PDI UT-8 Revision F and PDI UT-10 Revision C

Review of Changes

Brad Thigpen
Project Manager
PDI Piping & Bolting Program

<u>3-CIRC-01</u>

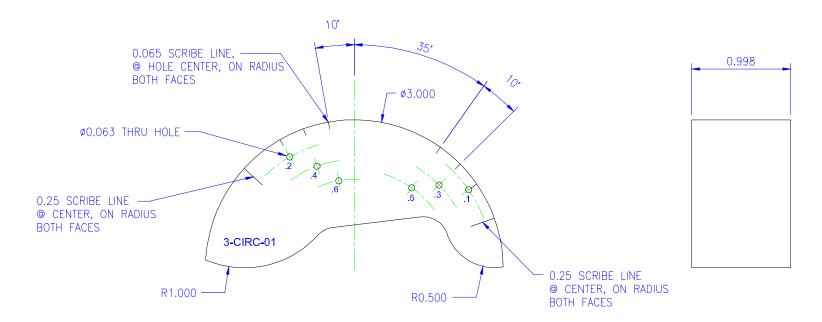
Incorporated a new reference block design
